Water Licence Inspection Report

On August 1, 2024, I, Isaiah James Bolt, Inspector with the Crown Indigenous Relations and Northern Affairs Canada (CIRNAC), writer of this report, Along with fellow inspector Jonathan Mesher, of CIRNAC, conducted an on-site visit of Hood Camp (8612-1)(2BE-IZO0712) to ensure compliance of their lease and water license.

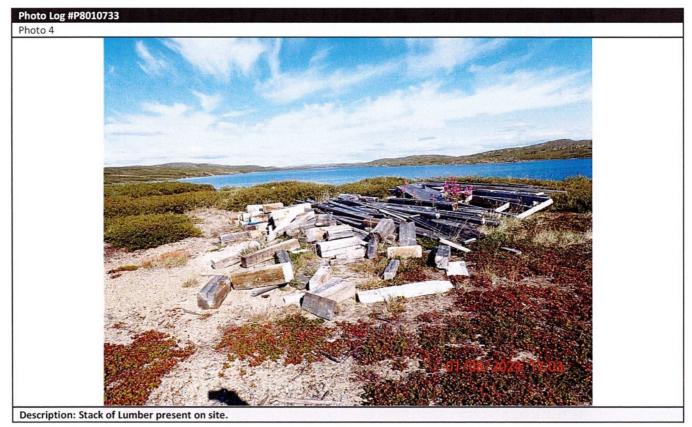
- 1. Inspectors arrived on site at 5:00PM on August 1st, 2024.
- 2. Aerial Photos were taken (Photo # 1 and #2)
- 3. Drill rods were present on site in a stacked manner. (Photo #3)
- 4. A pile of lumber was observed on site (Photo # 4)
- 5. Roofing material was stacked on top of a wooden wall in the tundra (Photo #5)
- 6. Ply wood debris observed on the ground behind the core shack. (Photo #6)
- 7. A small abandoned shack was observed on site with no roof and no door. There was nothing in the shack that would attract wildlife. Reclamation of this building is required. (Photo #7)
- 8. Core boxes were observed on the north side of the core shack. No issues noted. (Photo #8)
- 9. The door of the core shack was damaged and open. Signs of a bear breaking in were observed as the door was broken, scratched and chewed up (Photo #9)

-In regards to comment #3,#4, #5, #6, #7 and #11: Part I, Item 5 of the issued water license states: "The licensee shall remove from the site, all infrastructure and site materials, including all fuel caches, drums, barrels, buildings and contents, docks, water intakes, pumps and lines, materials and equipment prior to the expiry of this license".

Description: Stack of drill rod present on site.

-Remove all equipment related to the undertaking and restore the land back to its natural state. Information about the future plans of the core shack should be reported to the Inspector, (i.e., demobilization, deconstruction).

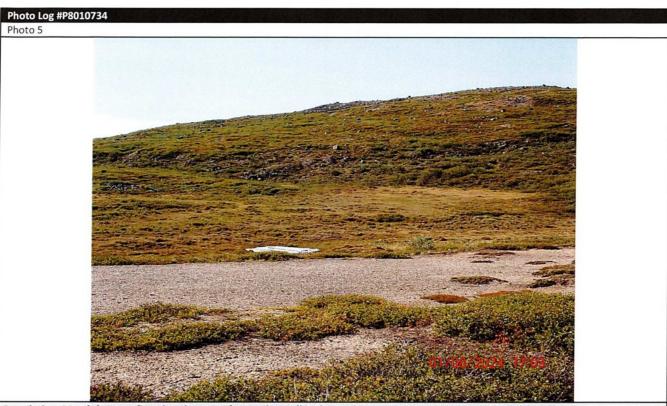
Description: Metal sheet roofing placed on top of a wooden wall in the tundra

Photo Log # P8010739 Photo 7

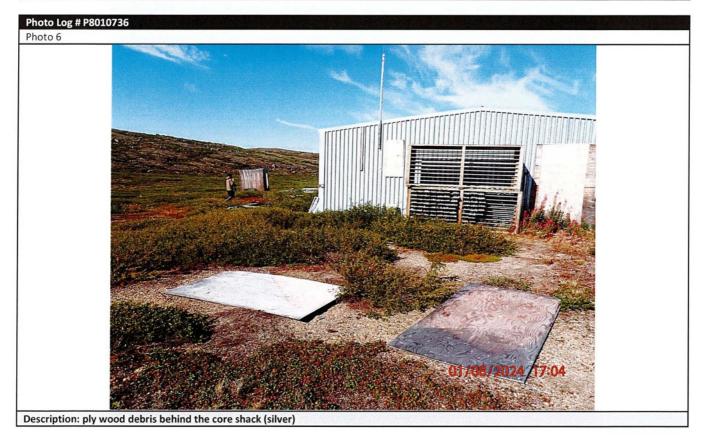
Description: Stacked drill rods, abandoned shack and some core boxes.

Photo 8

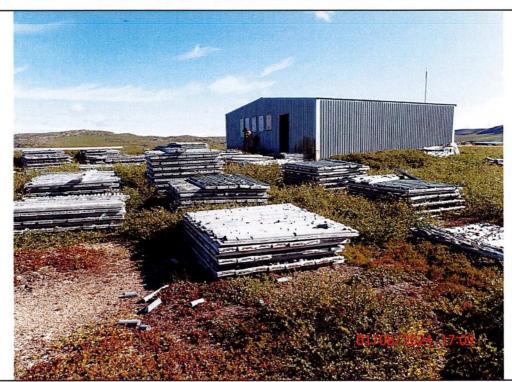
-In regards to comment #9 and #10: The building at Hood camp (core shack) should be repaired to deny entry of wildlife into the building.

Description: Core boxes outside, core shack (Silver) shown with an open door

-Ensure buildings that are housing core, are up to operational standards to deny entry of wildlife as per the Inspectors request.

Photo 11 Description: A large steel frame on the tundra close to where old cabins were situated.

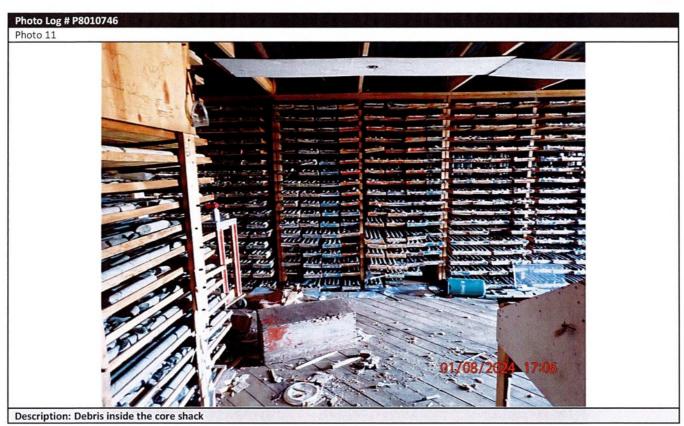
- 10. Signs of a bear staying in the core shack were observed. Debris and mess were observed all around the floor (Photo #10 and #11)
- 11. A steel frame was observed close to the shore of the lake (Photo #12)
